“Force-From-Below” Theory Inconsistent With Measured Hook Load

Figure 18 Recreation of Stress Engineering’s Effective Tension Graph

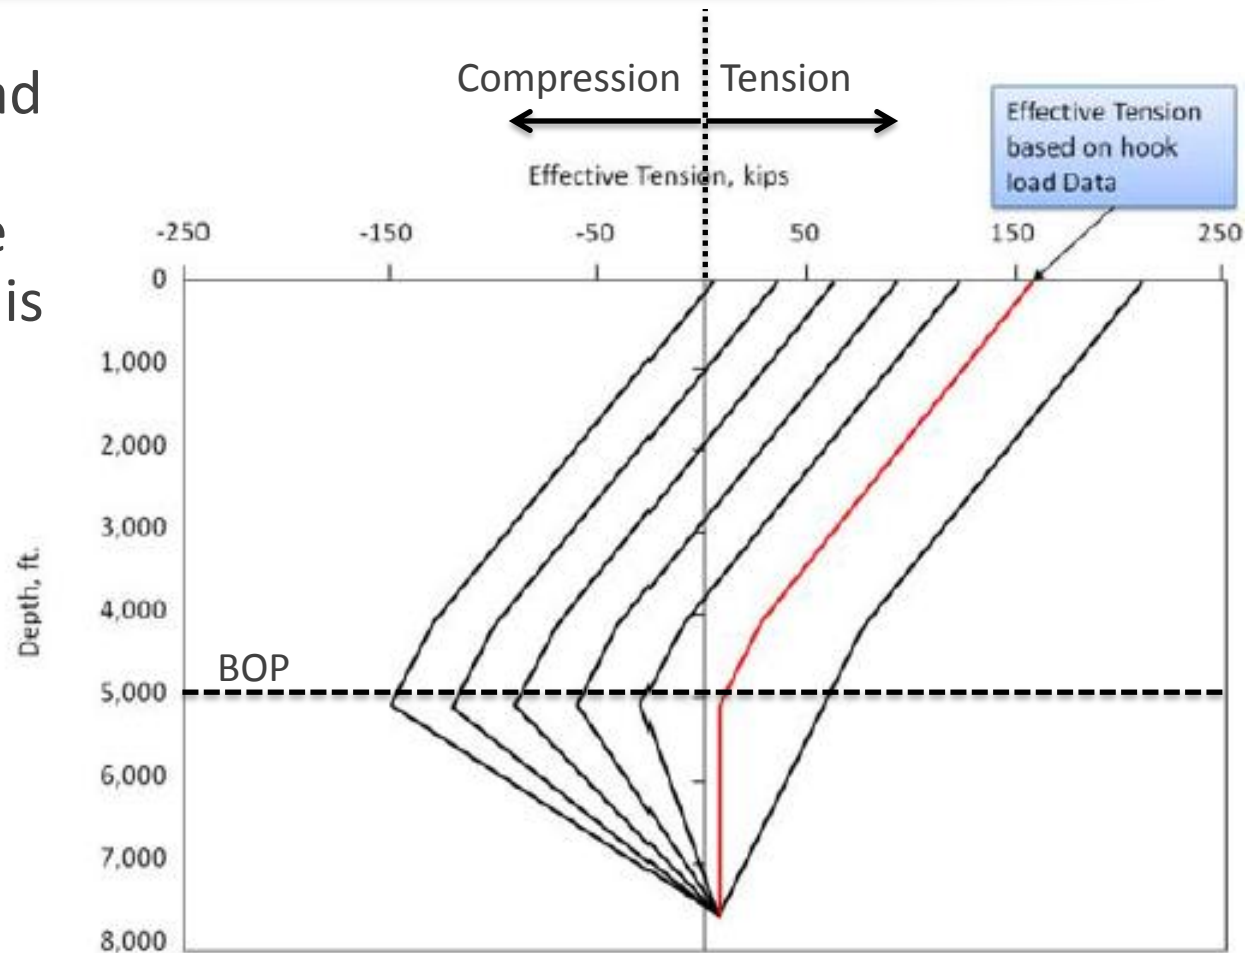
- When the hook load is applied to Stress Engineering’s force calculations, there is no compression in drill pipe
